2.2 Control and Instrument Systems

The information in this section of the reference ABWR DCD, including all subsections, tables, and figures, is incorporated by reference with the following departures.

Figure 2.2.1 Rod Control and Information System Control Interface Diagram

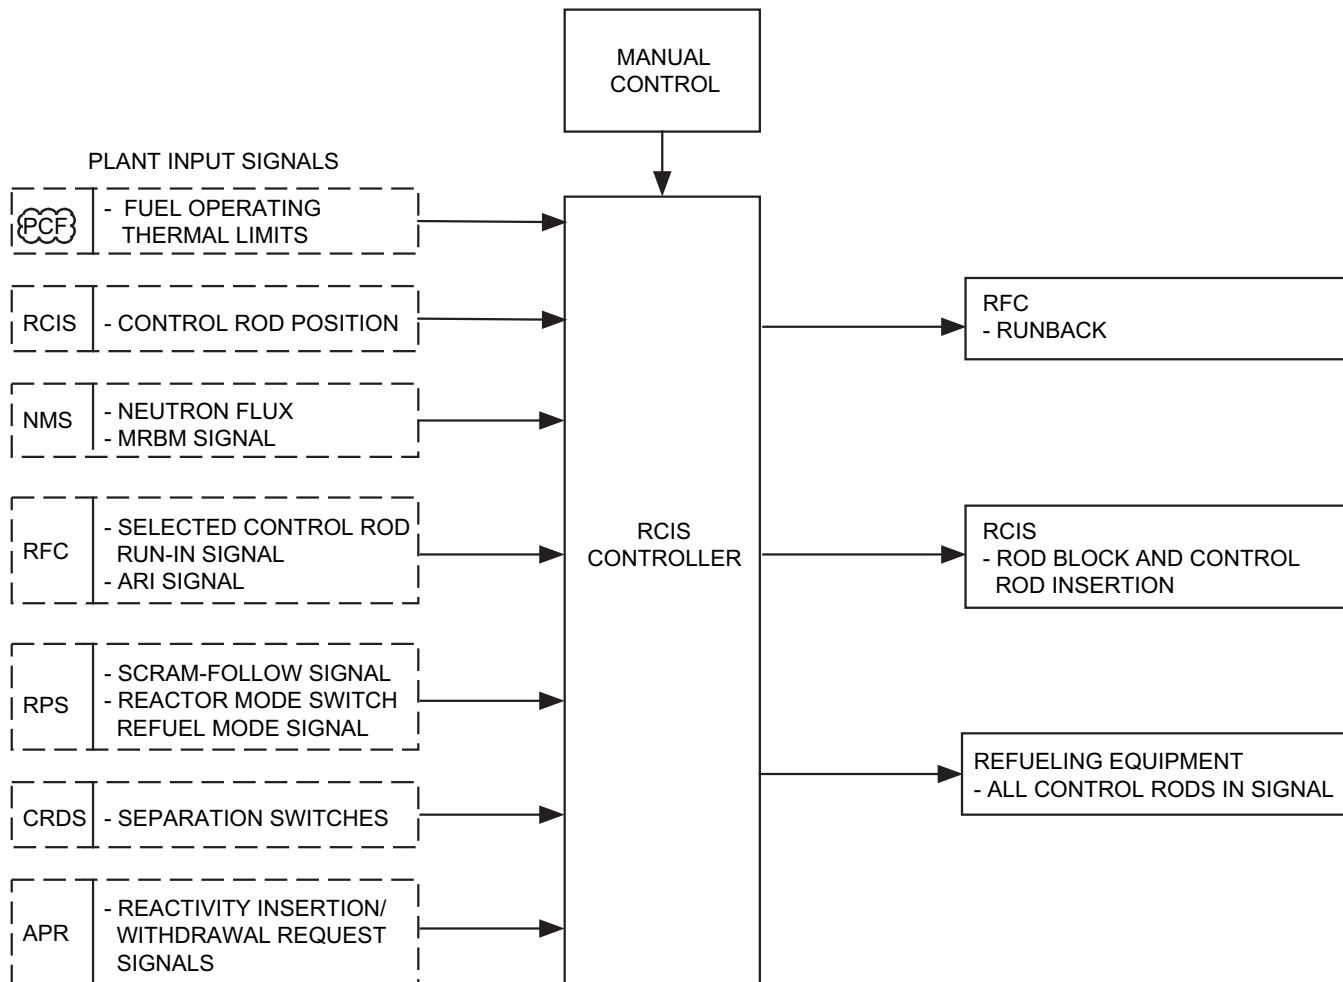
STD DEP T1 3.4-1 (Figure 2.2.1)

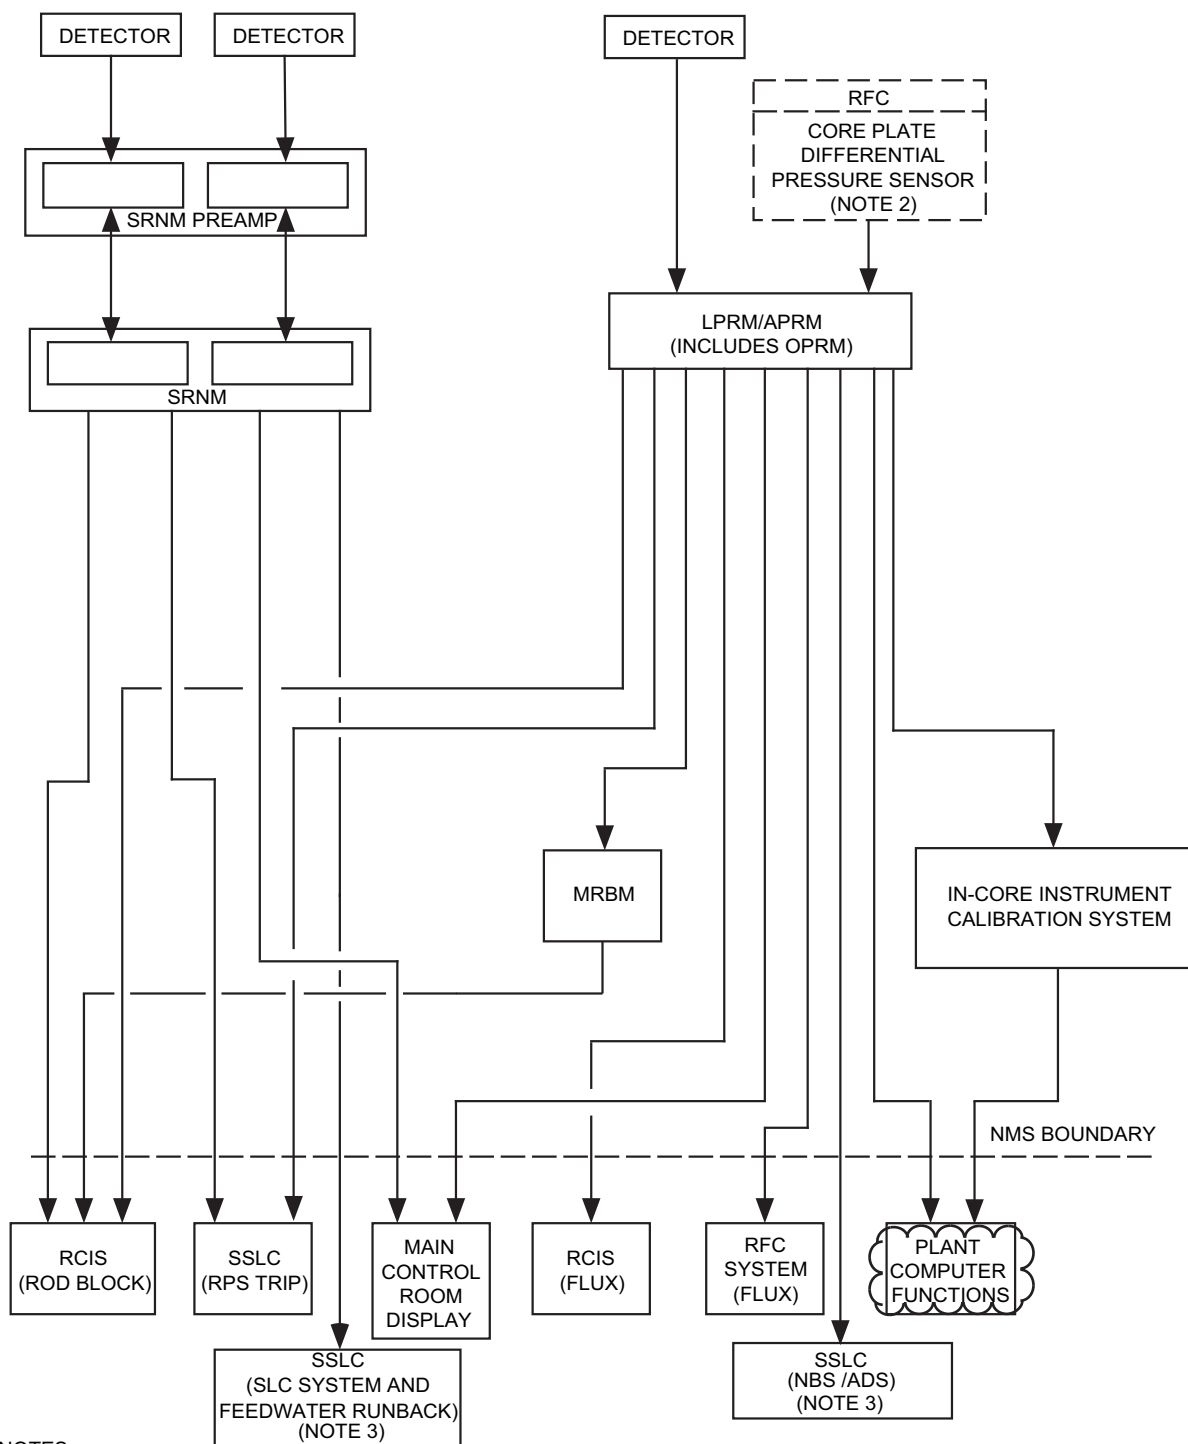
The FDWC digital controllers determine narrow range level signal using three reactor level measurement inputs from the NBS. ~~Sensor signals are transmitted to the FDWC digital controllers by the Non-Essential Multiplexing System (NEMS).~~

The steam flow in each of four main steamlines is sensed at the RPV nozzle venturis. ~~Sensor signals are transmitted to the FDWC System digital controllers by the NEMS.~~ These measurements are processed in the digital controllers to calculate the total steam flow out of the vessel.

Feedwater flow is sensed at a flow element in each of the two feedwater lines. ~~Sensor signals are transmitted to the FDWC digital controllers by the NEMS.~~ These measurements are processed in the digital controllers to calculate the total feedwater flow into the vessel.

Figure 2.2.5 Neutron Monitoring System

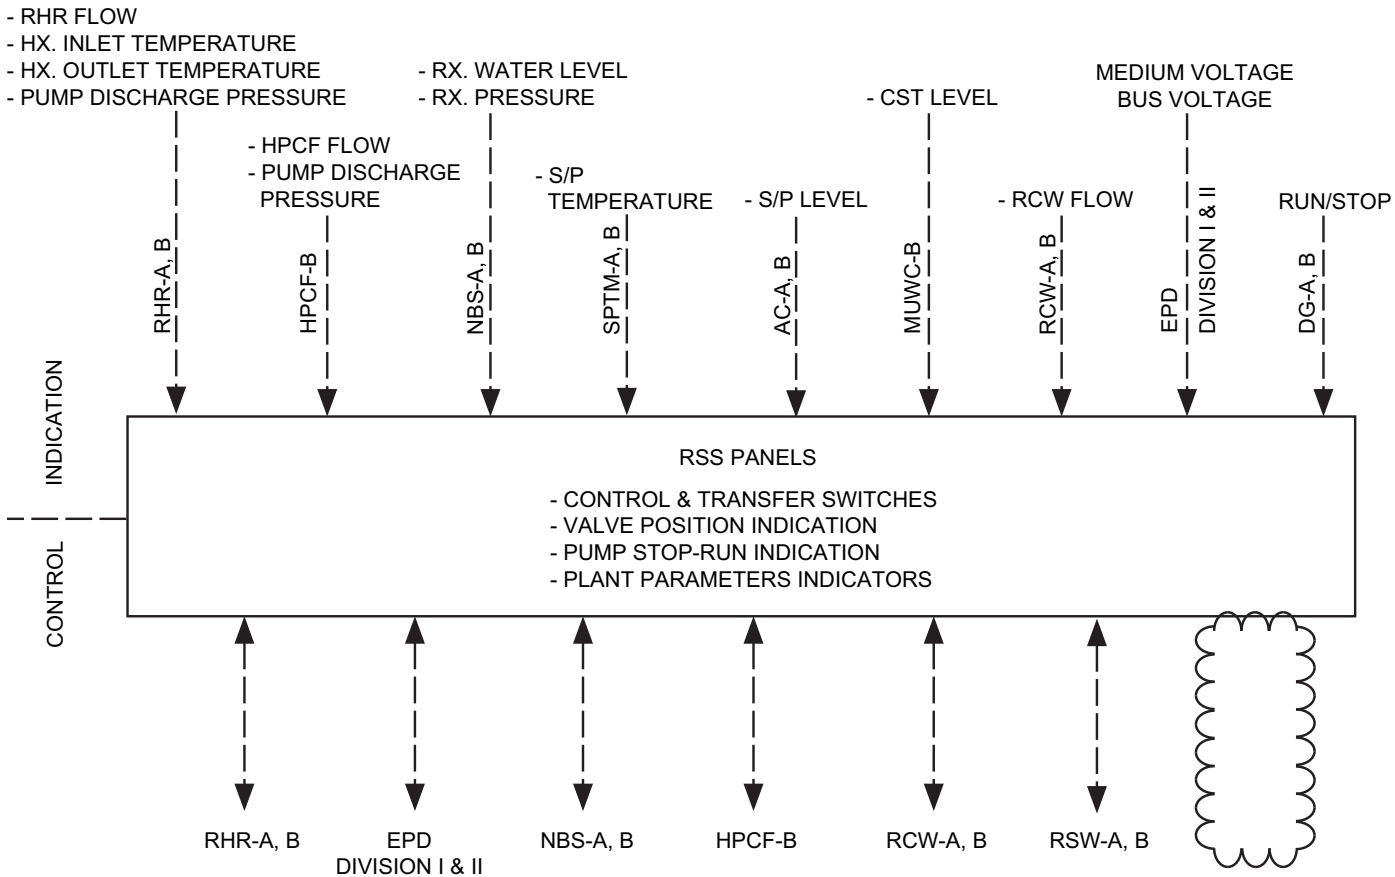
STD DEP T1 3.4-1 (Figure 2.2.5)

The automated in-core instrument calibration system provides local power information at various core locations that correspond to LPRM locations. The automated in-core instrument calibration system uses its own set of in-core detectors for local power measurement and provides local power information for three-dimension core power determination and for the calibration of the LPRMs. The measured data are sent to the ~~Process Computer System~~ Plant Computer Functions for such calculation and LPRM calibration.

Figure 2.2.7b Reactor Protection System

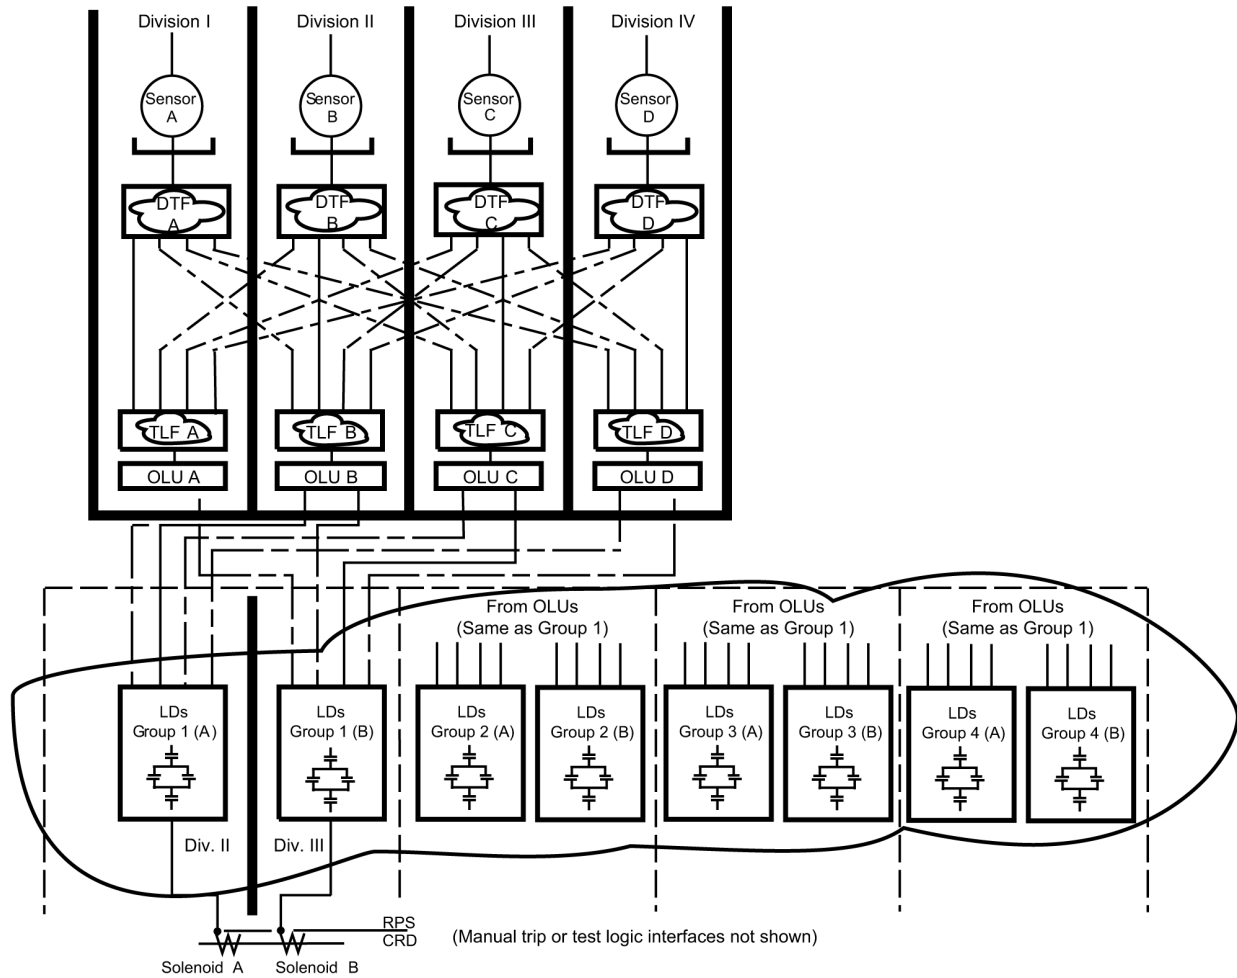
STD DEP T1 3.4-1 (Figure 2.2.7b)

The RPS has four divisions. Figure ~~2.2.6a~~ 2.2.7b shows the RPS divisional aspects and the signal flow paths from sensors to scram pilot valve solenoids. Functions Equipment within an RPS division consists of include sensors (transducers or switches), I/O, multiplexers, data communication, digital trip modules functions (DTM DTF), trip logic unit function (TLU TLF), output logic unit (OLU), and load drivers (LD). The LDs are only in Divisions II and III. The (DTF) and (TLF) are performed in digital configurable logic devices. The data communication functions are described in Section 2.7.5.
